Office Action Summary

10/737,124

KIM ET AL.

DETAILED ACTION

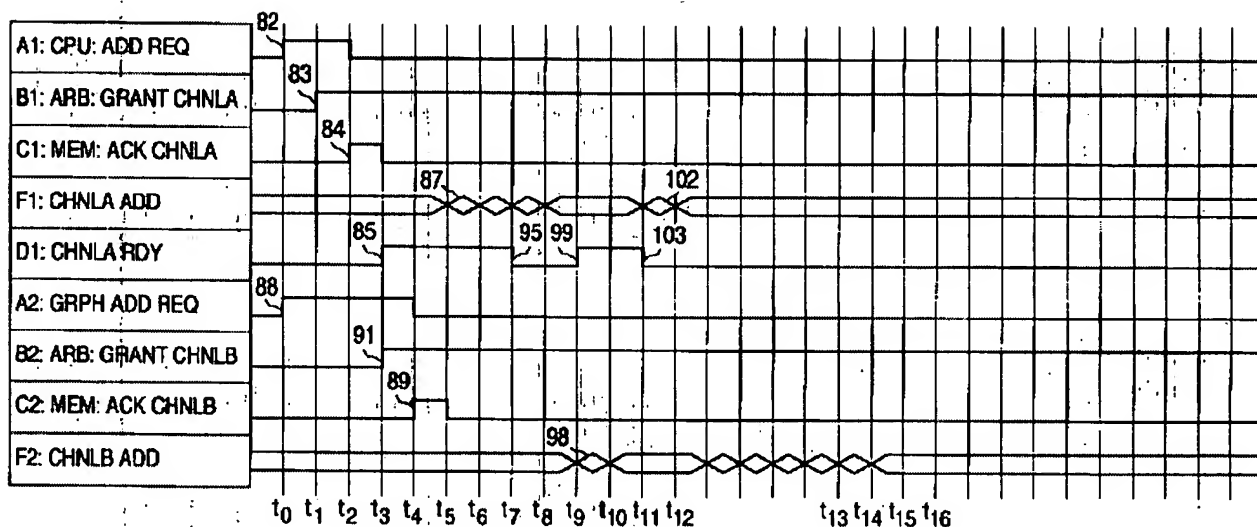
particular, in Kenny, a master module initializes bus access by asserting address and bus request signals on the bus 11. The arbiter 4 and the slave module detect the address and request signals asserted by the master module. The arbiter 4 then identifies the master module making the request, determines the master module's priority, and grants a virtual channel. The virtual channel granted can be arbitrarily selected by an allocation procedure. Specifically, Kenny discloses that "concurrent ownership of the data bus by multiple master/slave pairs advantageously enhances bus accessibility over conventional split-transaction bus protocols since the transactional overhead associated with bus re-acquisition protocols between a master/slave pair is eliminated. Since each channel, hence each master/slave pair, has its own unique channel active signal, data transfer between the master/slave pair commences immediately upon the arbiter asserting the appropriate "channel active" signal." Kenny further discloses that "FIG. 9 is a timing diagram summarizing concurrent transactions of three virtual channels of the present invention." In addition, Kenny discloses that "[a]ll concurrent virtual channel owners wait for an access grant by arbiter 4 to data bus 2. Access to data bus 3 to a particular virtual channel occurs when arbiter 4 asserts the virtual channel's active signal (e.g., CHNLA ACTIVE). Note that in Fig. 9, because the priority of each requesting master (CPU, PCI Controller, Graphics Controller) is not pre-assigned, the arbiter 4 must resolve the priority between requesting masters, and grants virtual channels A, B, C to each requesting master based on priority of each requesting master, by asserting signal GNT CHLNA, signal GNTCHLNB, and signal GNTCHLNC, at times t1, t3, and t5. Fig. 9 is reproduced below:

Kenny also discloses that the arbiter receives transaction information from all requesting master units in response to the pseudo-grant signals (after asserting signal GNT CHNLA, arbiter 4 returns to its initial state 47 to wait for the next ADD/REQ signal from each of the requesting master).

Although Kenny clearly disclose that pseudo-grant signals are generated to all the requesting masters. Kenny, as discussed above regarding Fig. 9, does not particularly disclose that the pseudo-grant signals begin at the same time, as claimed in at least Applicants' claim 1, and shown in Fig. 6, which is reproduced below:

Fig. 6

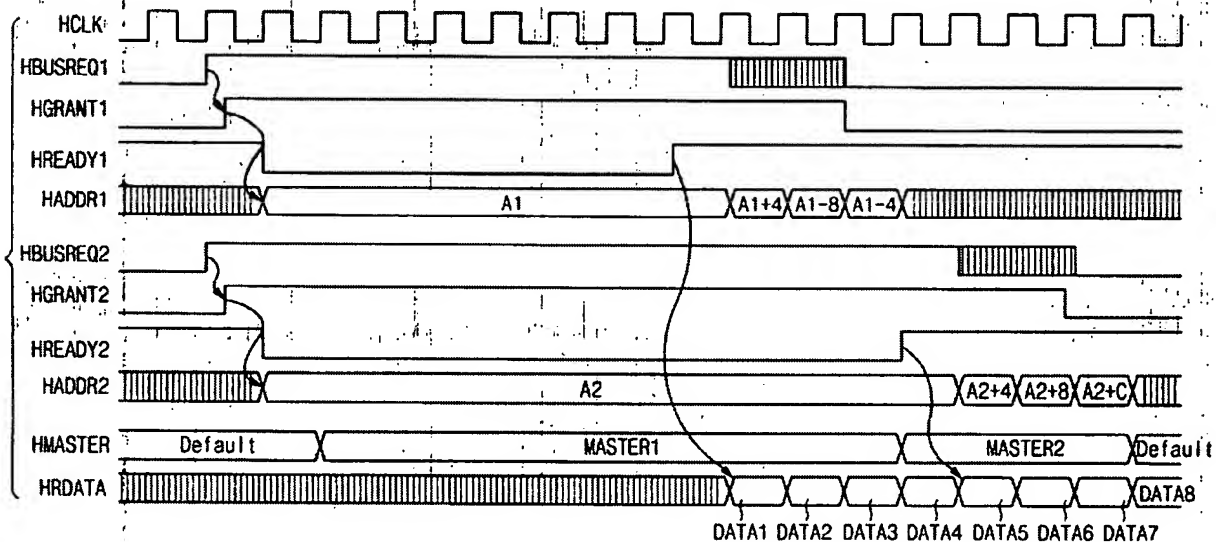
Note that in Fig. 6 above, the pseudo-grant signals HGRANT1 and HGRANT2 begin at the same time.
